Extension to Yunderup Canals Estate

Peel Waterways Pty Ltd

**Report and recommendations
of the Environmental Protection Authority**

**Environmental Protection Authority
Perth, Western Australia
Bulletin 541
June 1991**

Figure 1. Existing Yunderup Canal Estate showing location of proposed development sites.

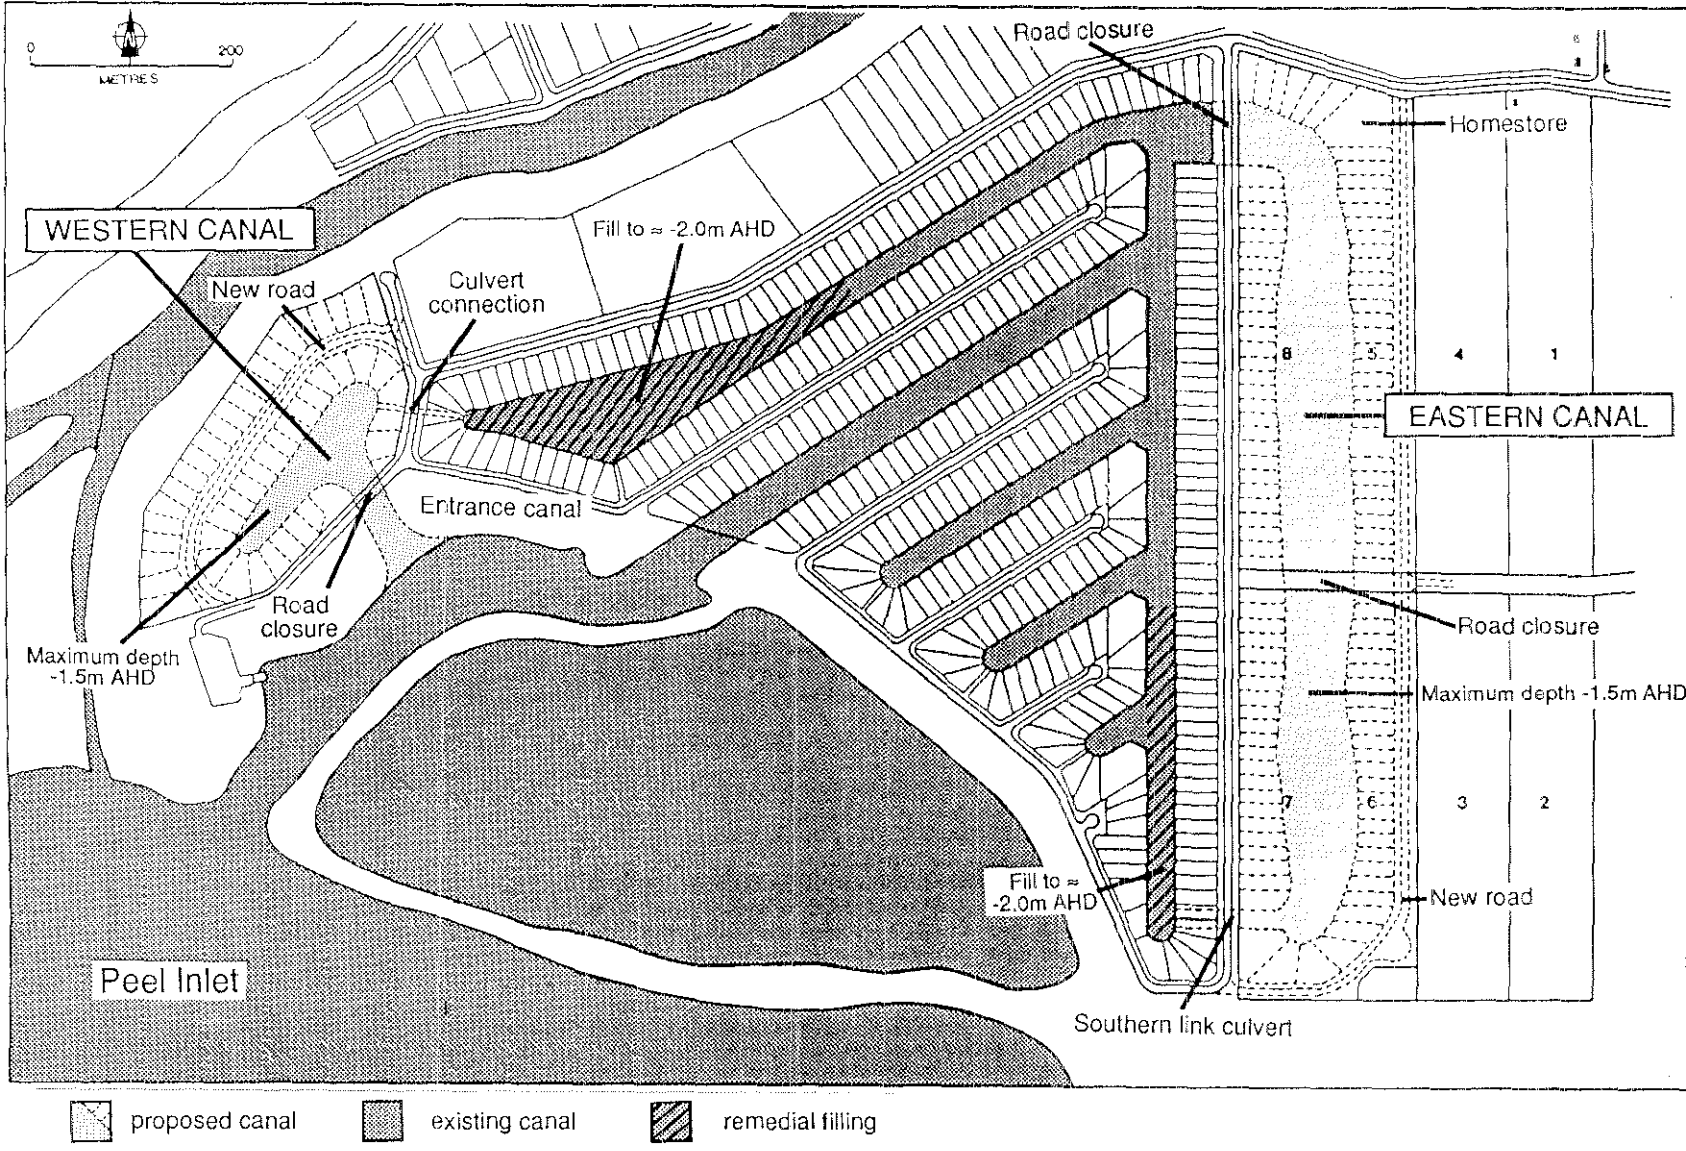
The flushing studies have also shown, through interpretation of the data collected, that the addition of Lots 5, 6, 7 and 8 Kiap Road to the canals will not have an adverse impact on the improved circulation of water within the system. The addition of Lot 18 Warma Way will also not have an adverse impact on the existing system because it opens onto the entrance channel in the Peel Inlet and is not directly connected or dependent on the rest of the canals for water circulation. In fact, Lot 18 will help to improve the flow of water through existing northern canal arm (F) by pipe or culvert connection.

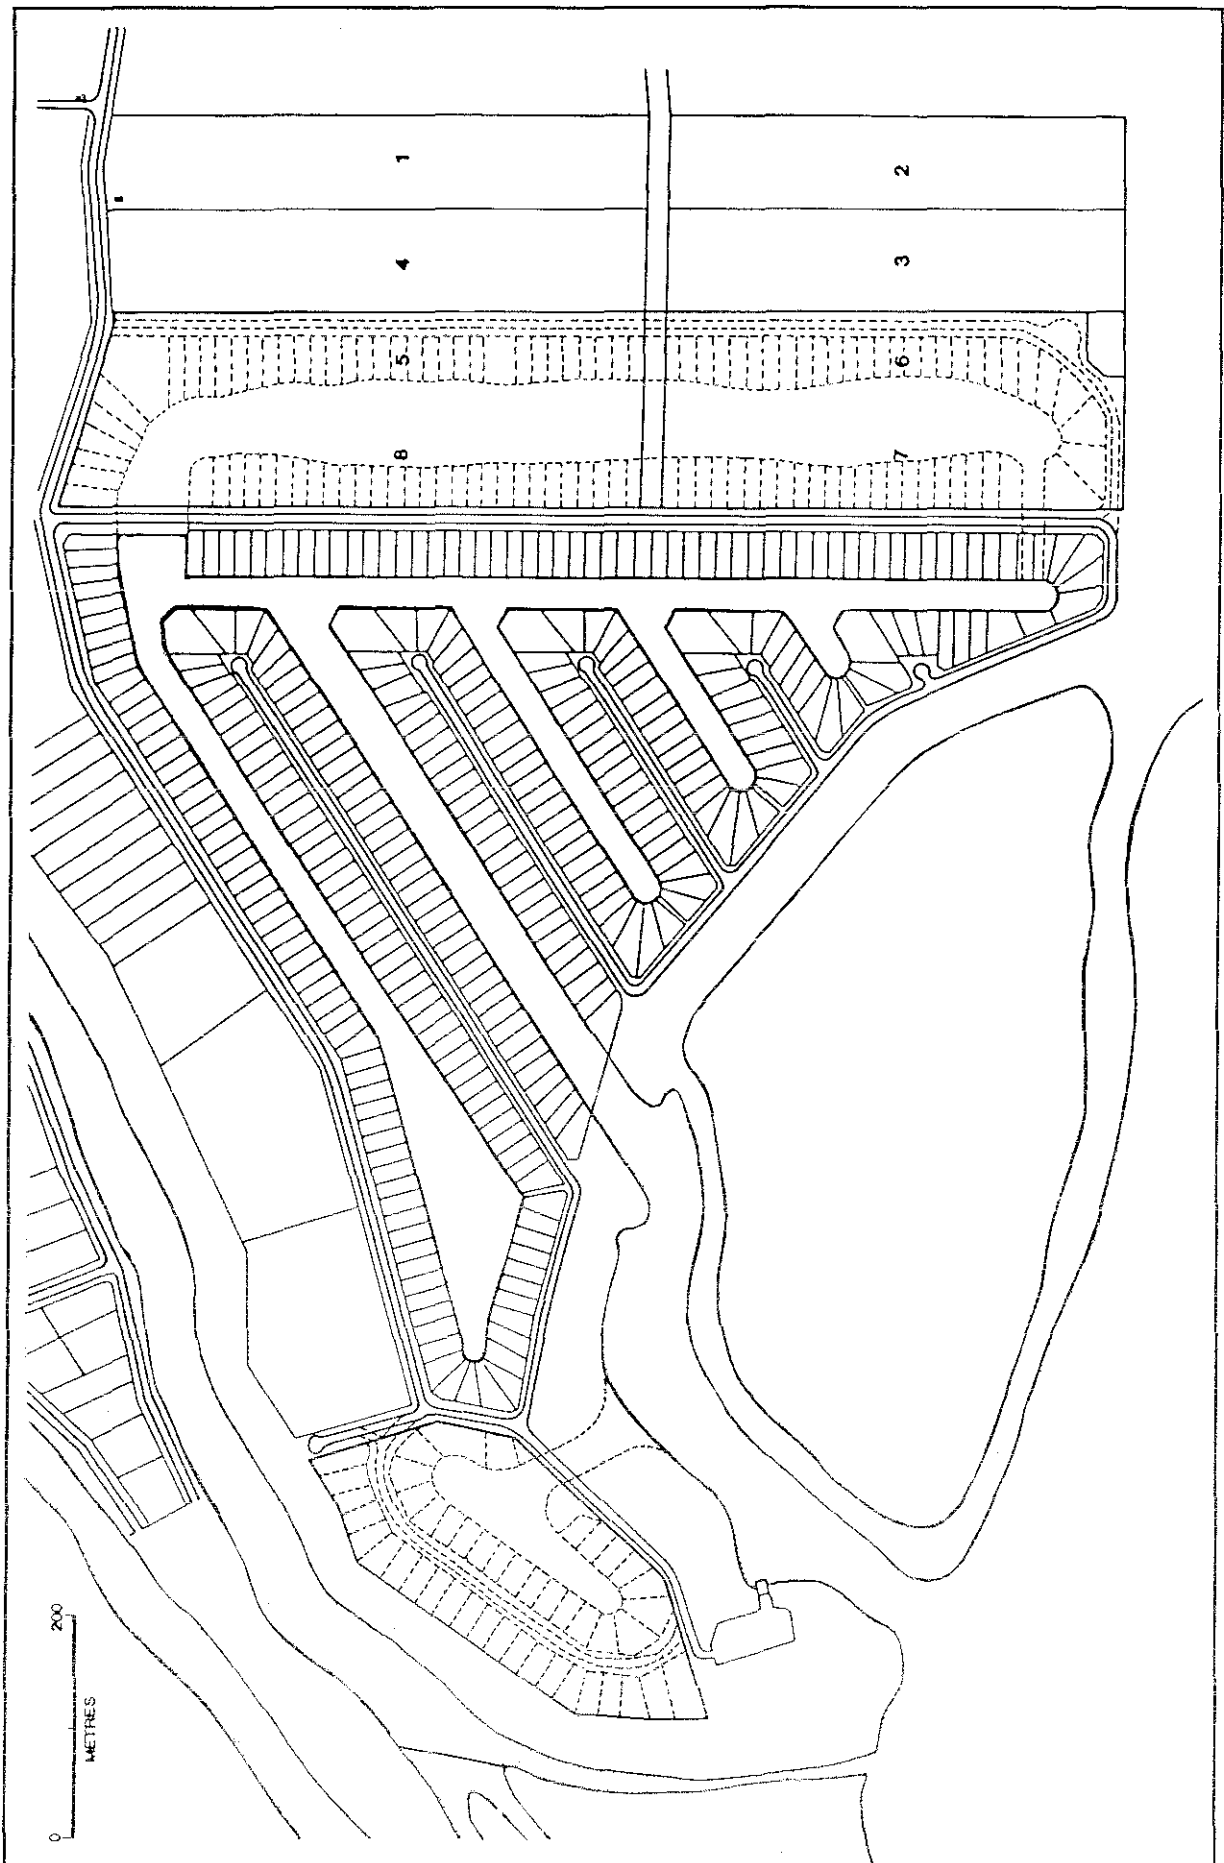
6) With reference to footbridges, the plans in the PER do not show a pedestrian/cycle access-way connecting the northern end of Kiap Road to Allambi Way. It is understood such a "bridge" was previously proposed. Certainly such a structure would be more than highly desirable at this location - in fact it should be considered essential to provide access to the Homestore.
